PRODUCT/PROCESS CHANGE NOTICE (PCN)

PCN #: Q1703-02 DATE: 2-May-2017 Product Affected: F1423NBGI(8) Date Effective: 2-Aug-2017	MEANS OF DISTINGUISHING CHANGED DEVICES: <input type="checkbox"/> Product Mark <input type="checkbox"/> Back Mark <input type="checkbox"/> Date Code <input checked="" type="checkbox"/> Other Materials used is traceable through Assembly Lot#
--	---

ATTACHMENT I - PCN # : Q1703-02

PCN Type: Change of Die Size

Detail Of Change:

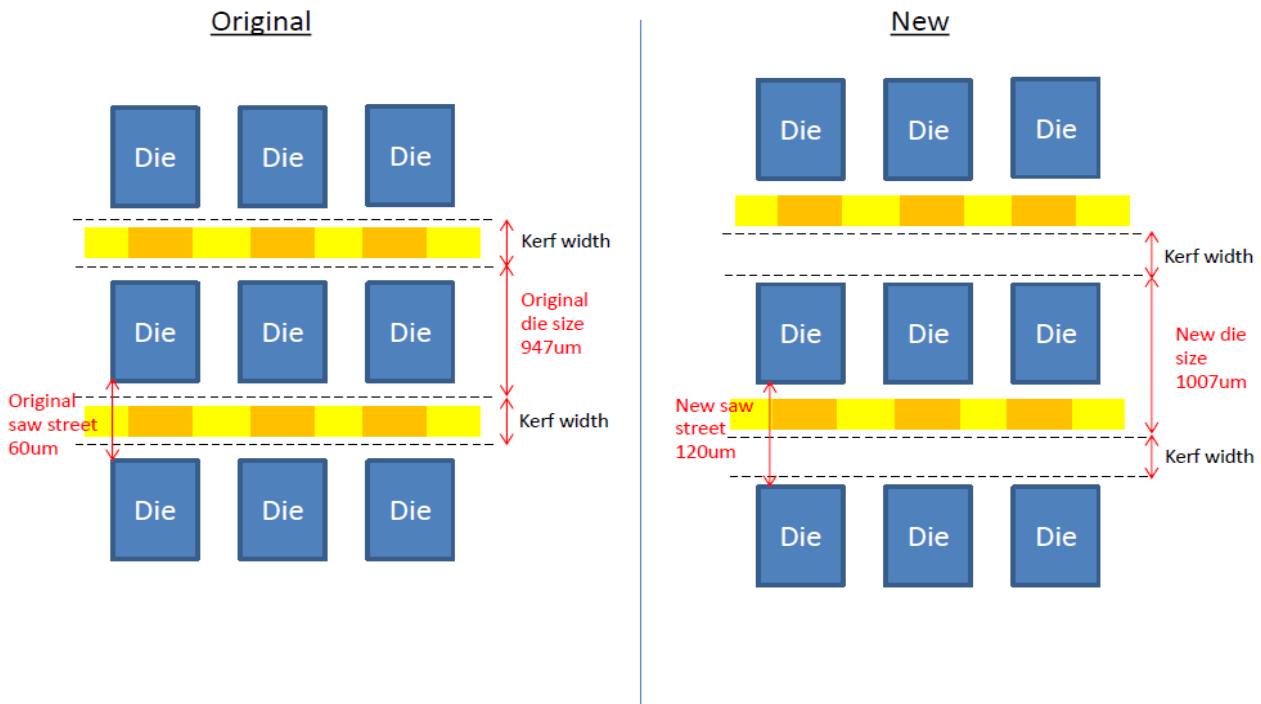
This notification is to advise our customers that select IDT parts are being converted to a 530um x 1007um die size from a 530um x 947um die size as a result of the increased to the saw street width dimension. This change is being made to improve manufacturing capability. Refer to the below illustration.
